WestConnex M4-M5 Link

Mainline Tunnels – Modification 7

Northcote Street Cul- de-sac

Response to Submissions Report

Figure 4-1: Extract from M4 East EIS, Appendix S, Figure 6.6 'non-aboriginal heritage items and heritage conservation areas – Haberfield and Ashfield'

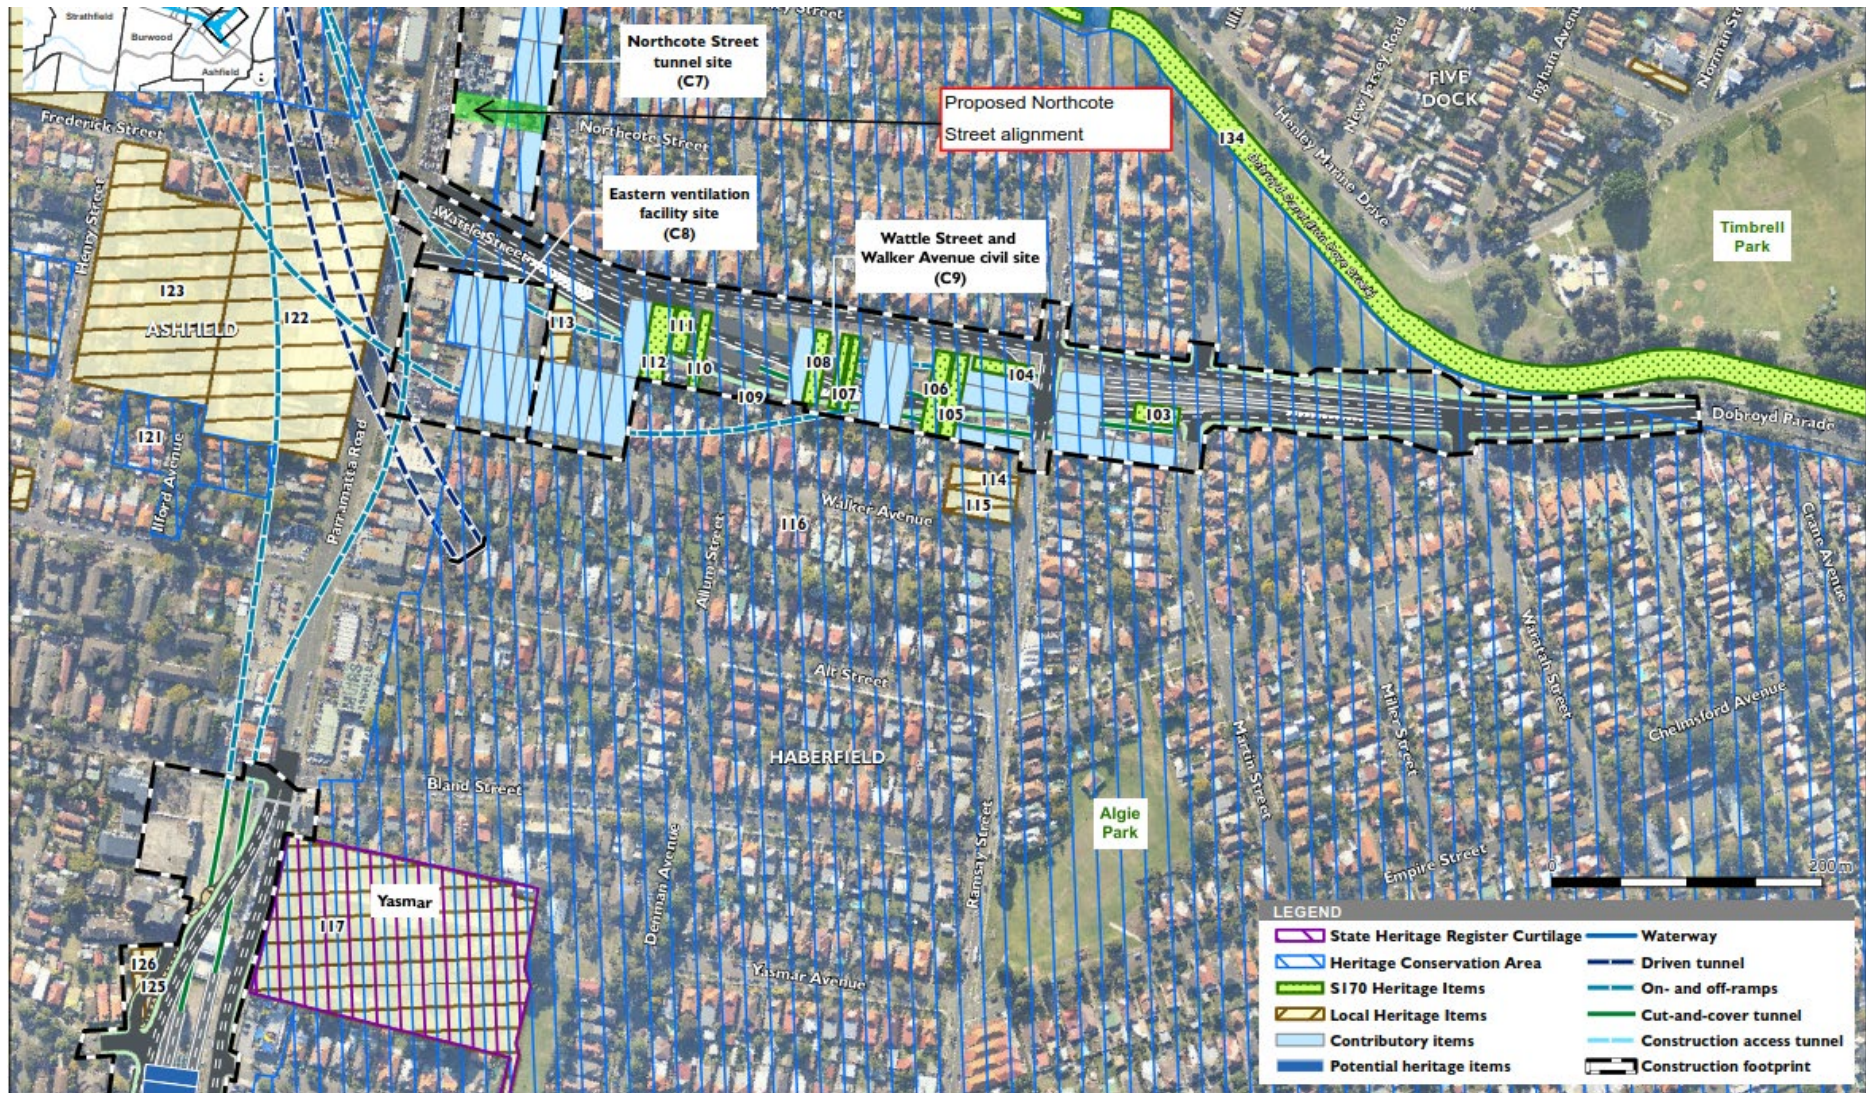
The design proposal was considered inadequate for 'green space' and portrayed a minimalist design. Responders requested increased trees and vegetation in replacement of the proposed shrubs and provided comment that the design looked out of character and did not share similar aesthetic values with the area identified as the 'Garden Suburb'.

The Non-Aboriginal heritage impact assessment under Appendix S of the M4 East EIS further shows Northcote Street partially intercepting the HCA area, refer to Figure 4-1, which identifies other 'contributory' and 'S170 heritage' listed items.

The interim proposed design for the Northcote Street alignment is partially located within the HCA as identified in the M4 East and M4-M5 Link EIS. Given the neutral and no impact rating assessed for archaeological and heritage items within the Northcote Street area under the M4-M5 Link occupation, it is considered the rating will apply to the proposed interim modification.

Figure 4-2 Ramsay St/ Wolesey St Weekly Traffic Profile

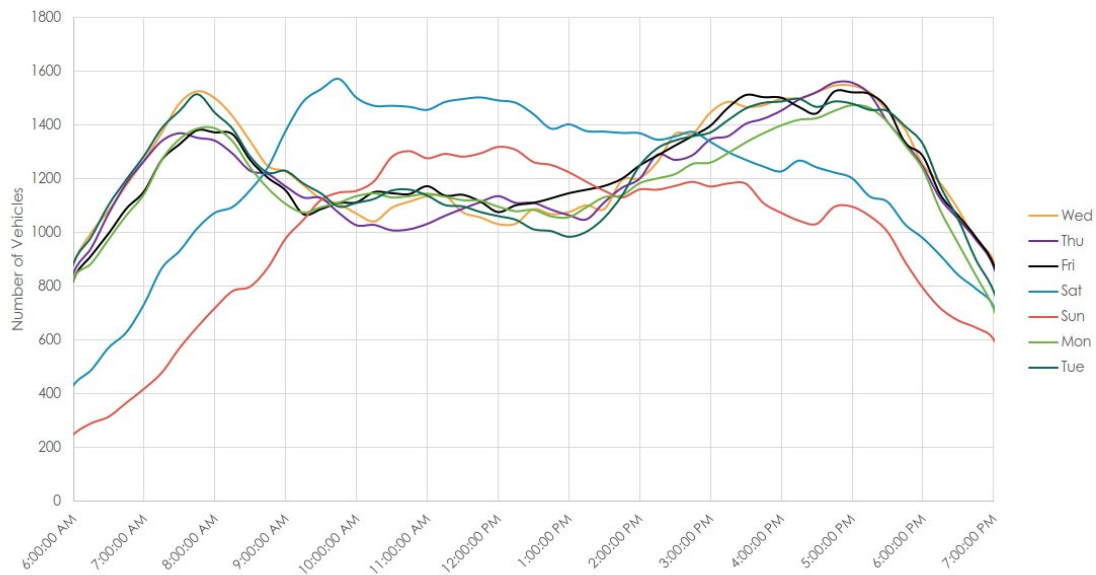
Submitters raised concerns that the proposed modification only benefits residents on Northcote Street and disadvantages those on Wolseley Street. Since the initial closure of Northcote Street, Wolseley Street has experienced increased traffic and has turned into a 'rat-run' from vehicles using an alternative route to access Parramatta Road from Ramsay Street. Concerns were also raised regarding the safety to the residents on Wolseley Street.

The daily traffic profiles recorded at the Wolseley Street /Ramsay Street intersection and Northcote Street/ Ramsay Street intersection across a 14-hour period (6:00am – 8:00pm), as shown in Figure 5 and Figure 6 of the traffic assessment, Appendix C of the Modification Report, show similar daily volumes. Refer to Figure 4-1 and Figure 4-2.

The level of service (LoS) from the daily profiles confirmed both intersections operate under a 'good' to 'satisfactory' level.

This suggests there has been little impact to both Wolesey Street and Northcote Street intersections with Northcote Street in its current configuration. The modification proposes to leave Northcote Street in this configuration.
